RE: St. Lucie Unit 1
Docket No. 50-335
Proposed License Amendment
Alternative Source Term and Conforming Amendment

Pursuant to 10 CFR 50.90, Florida Power & Light Company (FPL) requests to amend Facility Operating License DPR-67 for St. Lucie Unit 1. FPL proposes to revise the St. Lucie Unit 1 licensing bases to adopt the alternative source term (AST) as allowed in 10 CFR 50.67.

Regulatory Assessment of the Proposed Implementation of the
Alternative Radiological Source Term Methodology
for the St. Lucie Plant, Unit No. 1

PLANT SYSTEMS

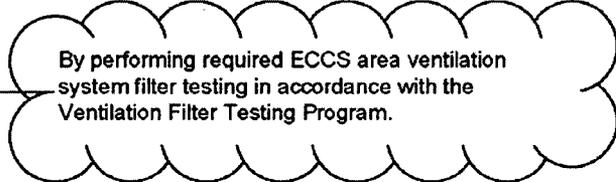
1. ~~Verifying that the charcoal adsorbers remove $\geq 99\%$ of a halogenated hydrocarbon refrigerant test gas when they are tested in place in accordance with ANSI N510-1975 while operating the ventilation system at a flow rate of 30,000 cfm $\pm 10\%$.~~

2. ~~Verifying that the HEPA filter banks remove $\geq 99\%$ of the DOP when they are tested in place in accordance with ANSI N510-1975 while operating the ventilation system at a flow rate of 30,000 cfm $\pm 10\%$.~~

- The HEPA filter and charcoal adsorber test acceptance criteria for the ECCS Area and Shield Building Ventilation Systems relocated to the VFTP are revised as follows:
